City of Plymouth Planning Commission Regular Meeting Agenda Wednesday, February 9, 2022 – 7:00 p.m. City Hall & Online Zoom Webinar

TO: City of Plymouth Planning Commission
FROM: Sally M. Elmiger, AICP, LEED AP
DATE: February 3, 2022
RE: Westborn Market – Revised Site Plan for Parking Lot Expansion

**Planned Unit Development
For
City of Plymouth, Michigan**

PULTE HOMES OF MICHIGAN, LLC
PLYMOUTH MULTI-FAMILY
AMENDED PRELIMINARY PUD PLAN
ORIGINAL CONDITIONS

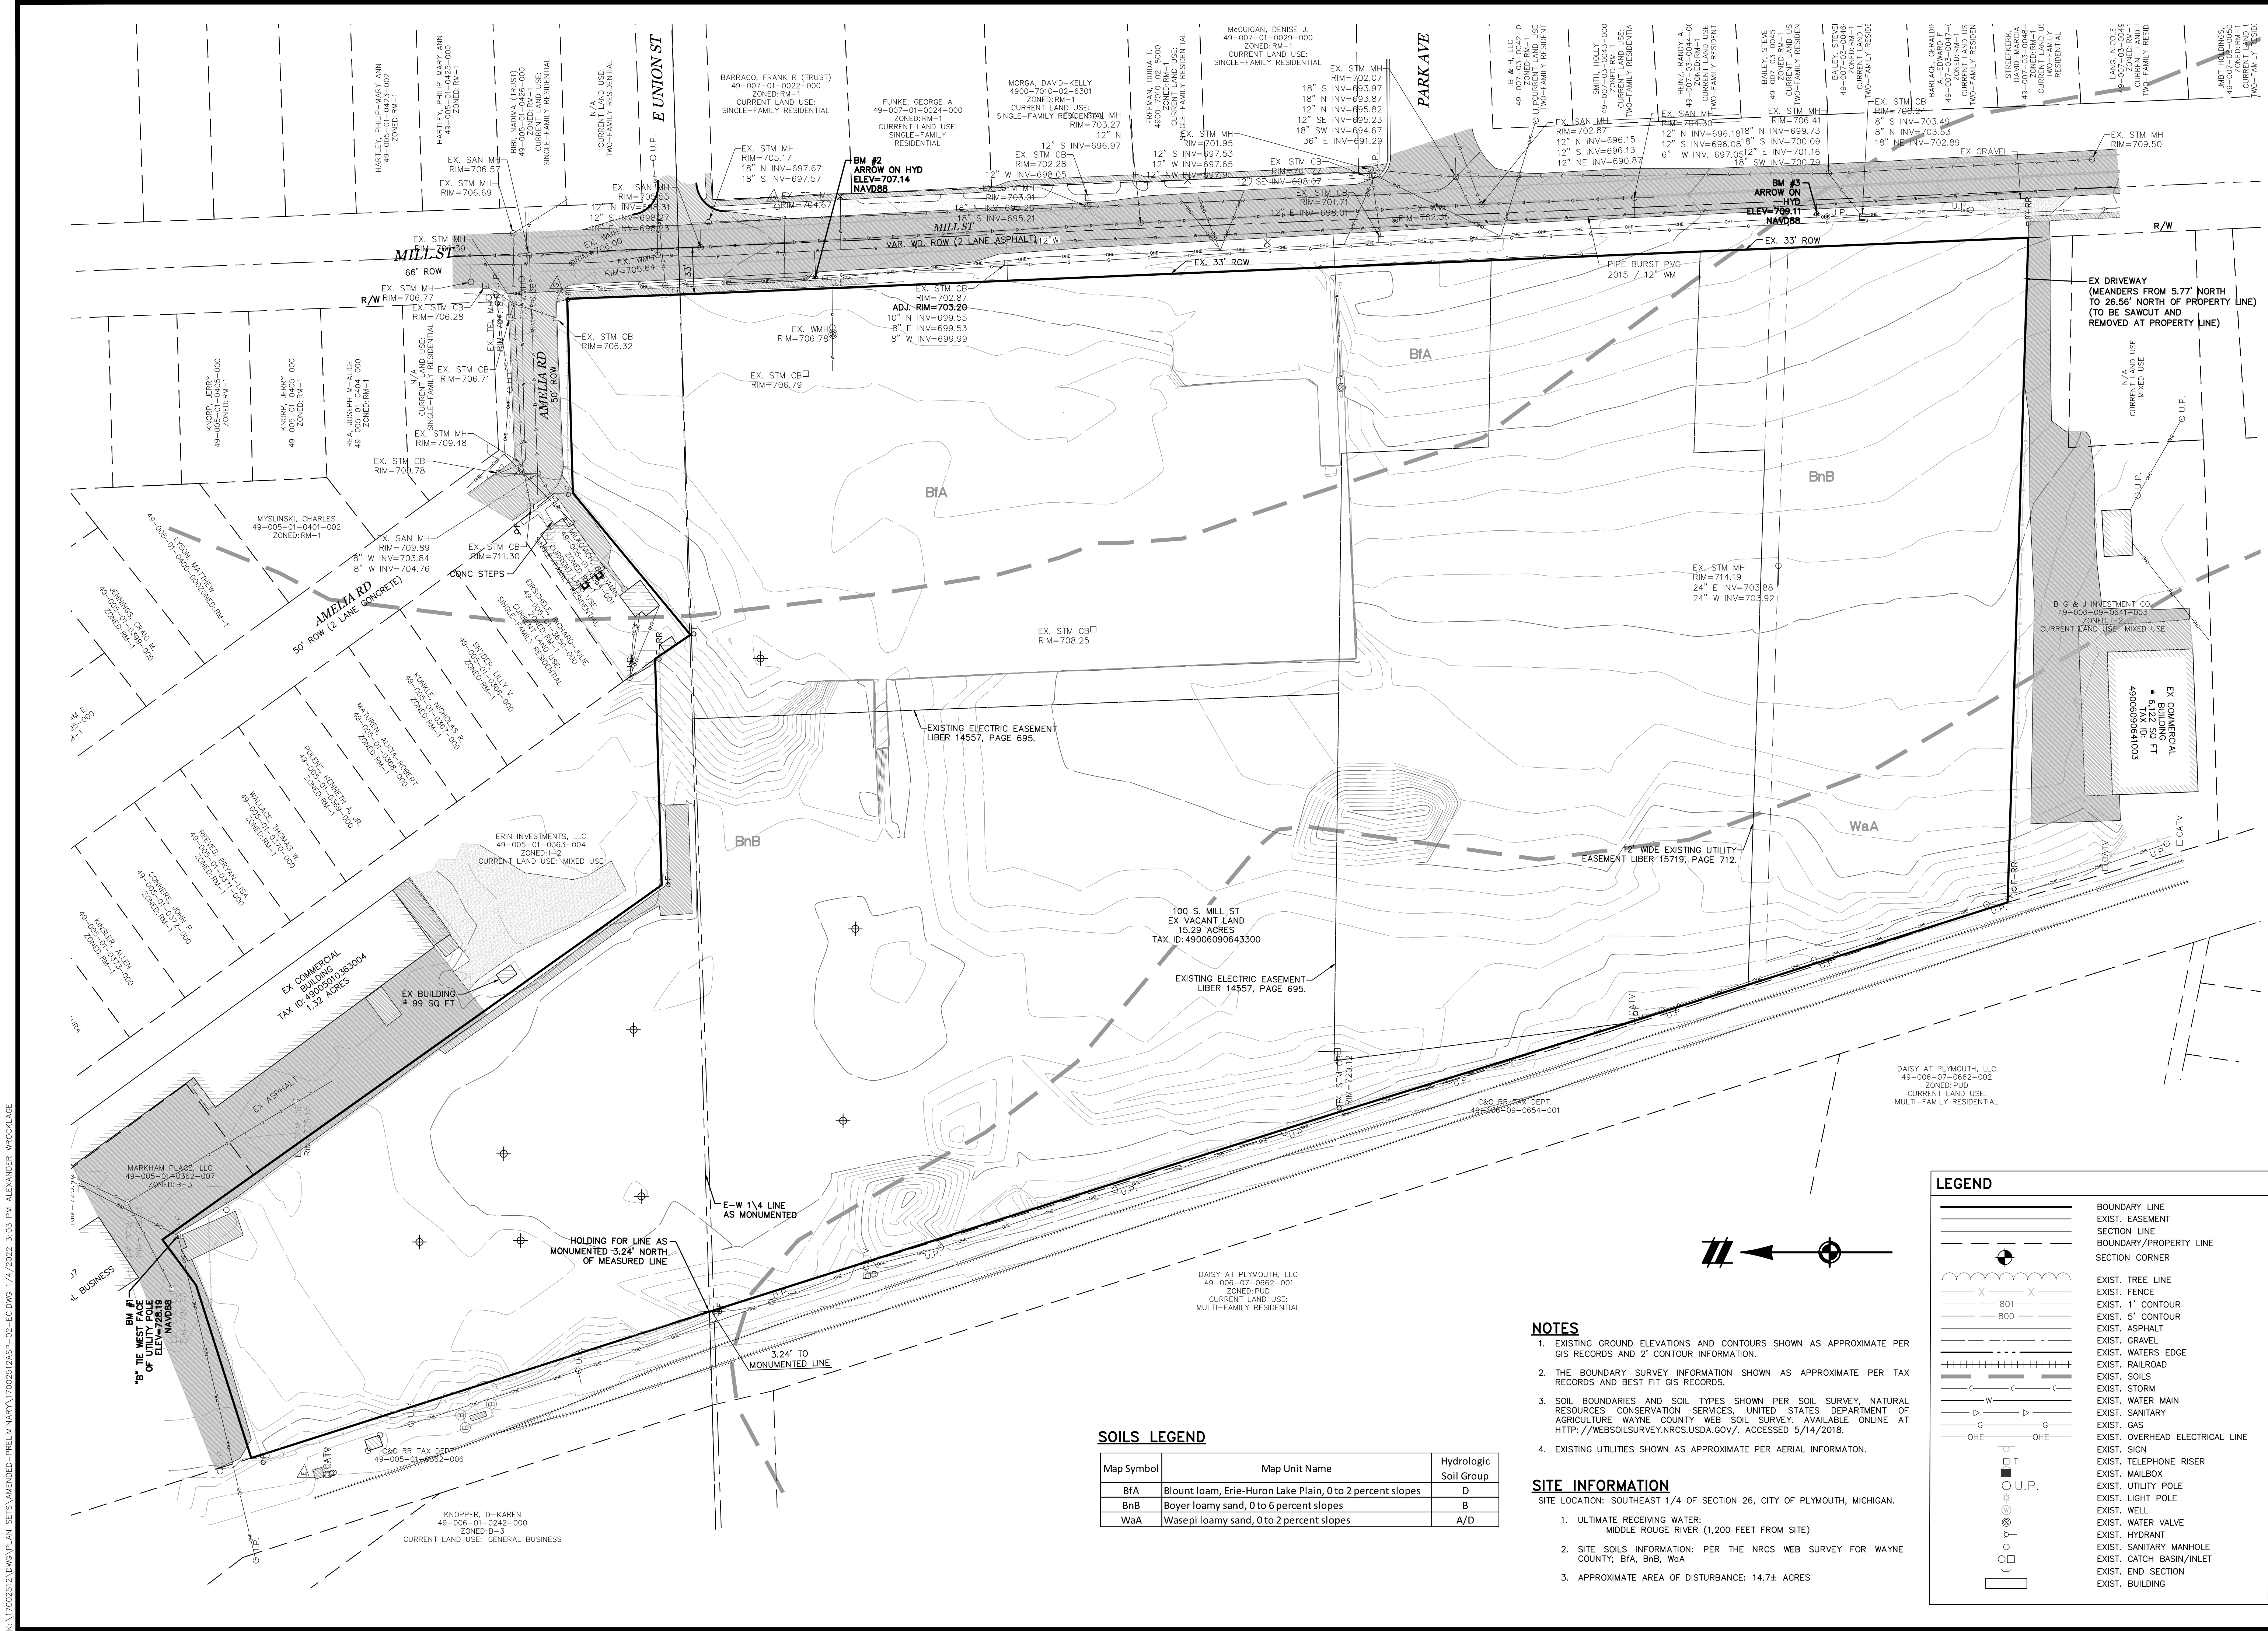
1. Narrative report providing a description of the project, discussing the market concept of the project, and explaining the manner in which the criteria set forth in the design standards has been met.
2. Sheet 2, Existing Conditions, needs to be amended to show the following:
 - a. Current zoning of site (PUD) showing “exempted” area.

- b. Surveyed property lines, and dimensions. A note on this sheet states that the property boundaries are approximate per tax records, and “best fit” GIS records. The ordinance requires accurate information, not approximations.

- c. Actual topography on the northern portion. Again, the plans show “estimated” topography. The ordinance requires accurate information.
 - d. Actual existing conditions on the southern portion. This sheet shows the southern portion before it was developed. Since this request is amending an existing PUD, accurate information that illustrates the current development, including building locations, roads, sidewalks, and topography, needs to be shown on this sheet to understand the relationship of the current conditions on each portion of the site. Showing it on the grading plan is not sufficient.

Items to be Addressed: *Provide Preliminary site plan and PUD informational requirements.*
